Response letter to Reviewer#2

We thank Dr. Daniel Thewes for the careful consideration of our work. We agree with his constructive and thoughtful comments and suggestions, which led to a much improved and complete manuscript. In this response letter, we have replied (in blue) to all the comments formulated by the Reviewer (in black).

Fig. 2. Illustration of the S-hydrograph and instantaneous UH analytically computed using Eqs. (7) and (9), respectively, for given values of $\beta_1=\beta_2=3$ and $t_p=10$.

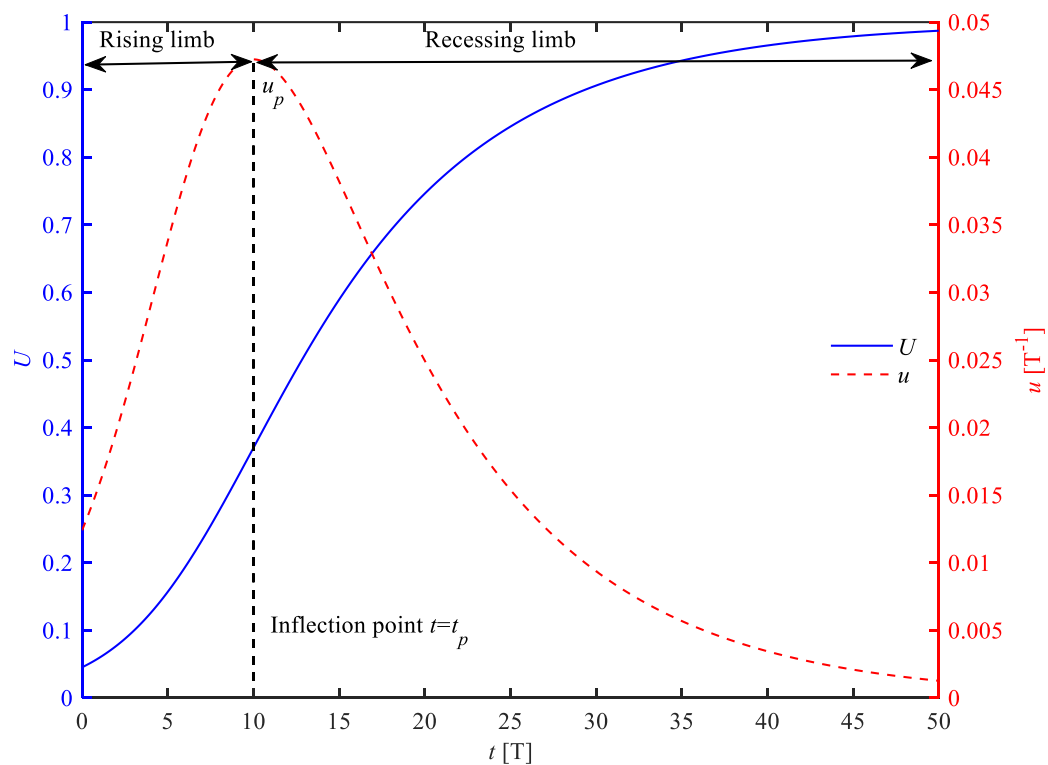
7. “ t_p ” is only introduced in line 81, but might also be reflected in figure 1 and 2, for extra clarity.

Our reply: We very much appreciate the reviewer’s suggestion. In the revised manuscript, we shall update the Figure 2 as follows.

Fig. 5. Response of dimensionless salt intrusion length L^* to the dimensionless parameters μ and m for a given salinity threshold $S_f^* = 0.01$.

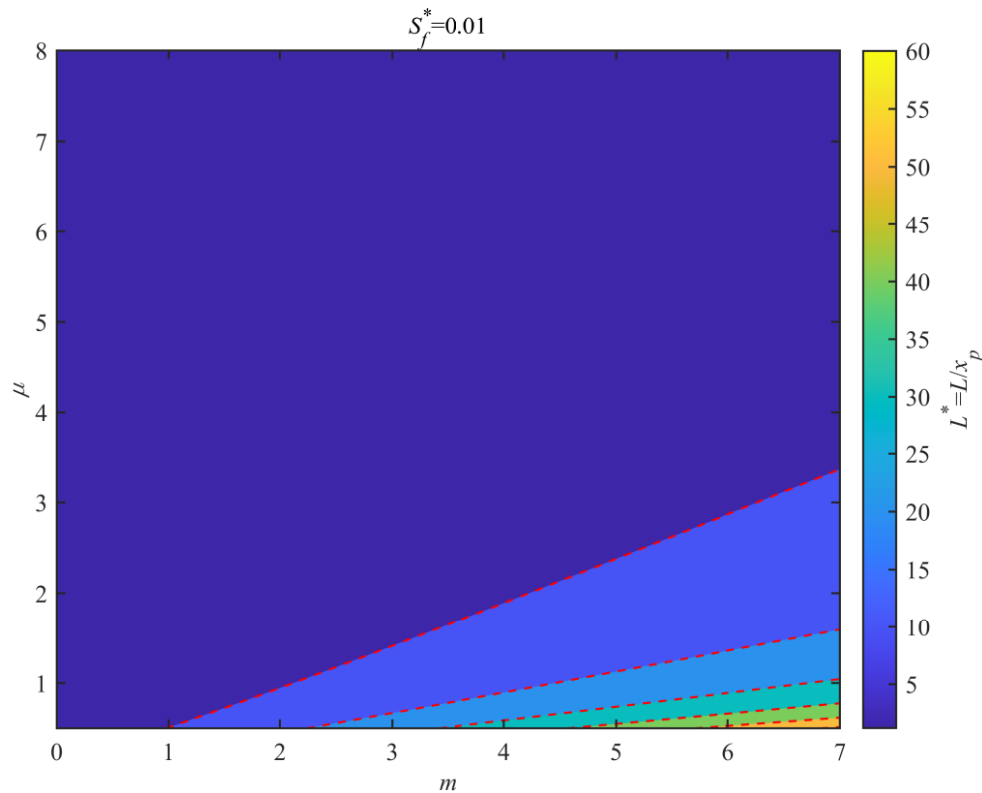
15. Figure 5 has y-limits of 0.5 and 5, yet table 1 has values of μ from 0 to 6. m goes from 0.1 to ~6. L is regularly larger than 18 in the table. Consider adapting figure 5 in such a way that it covers the table’s values.

Our reply: Many thanks for the suggestion. Note that the L^* represents the dimensionless salt intrusion length that is scaled by the inflection point x_p . In the revised manuscript, we shall update the Figure 5 as follows:

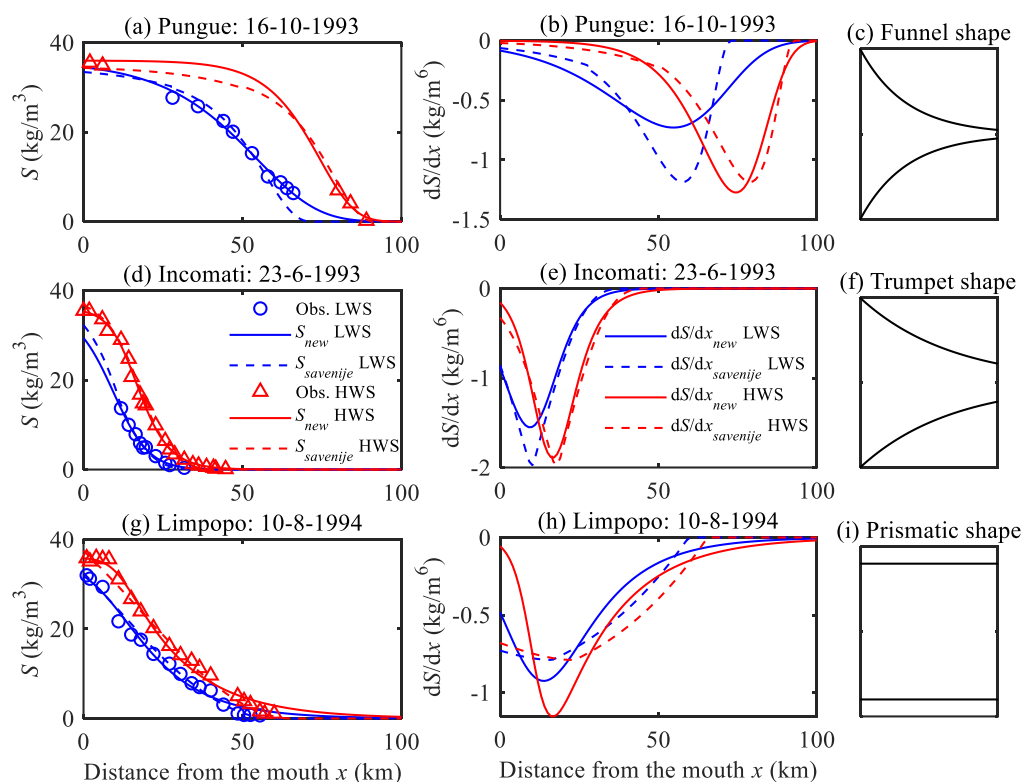
16. Lines 229ff: While figure 7a does show the Pungue estuary, Incomati is 7c and Limpopo 7e.

17. Figure 7: add x-label. Typically, distance along rivers is measured from source to sea. It therefore makes sense to state, explicitly, that this is sea to source.

18. Again, lines 229ff.: the shapes of the estuaries are named in the text (only explained in Savenije, 2012), but they could be shown in idealised form in a third column of figure 7, i.e., draw a funnel, a trumpet and a prism shape. This can be very rough and idealised.

Our reply: In the revised manuscript, we shall correct these mistakes.

Our reply: Many thanks for the suggestion. In the revised manuscript, we shall update the Figure 7 as follows:

Our reply: Many thanks for the suggestion. In the revised manuscript, we shall update the Figure 7 (see figure above).

Fig. 8. Longitudinal variations of the dimensionless salinity S^* (a, b) and its gradient dS^*/dx^* (c, d) along the estuary axis for different values of input parameters. The solid and dashed lines indicate the solutions obtained by Savenije’s model and newly proposed model, respectively.

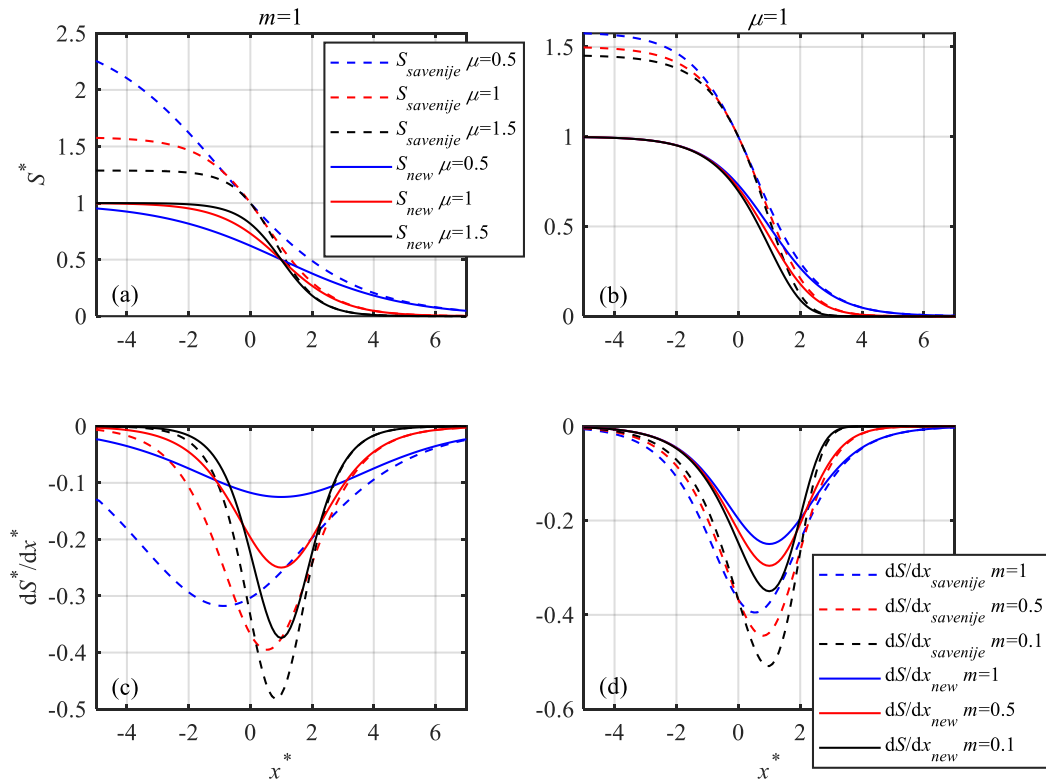
22. Figure 8 and line 267: why are dashed and solid lines switched, with respect to figure 7? Consistency between the figures would be favourable.

Our reply: We agree with the reviewer’s comments. In the revised manuscript, we shall update the Figure 8 as follows:
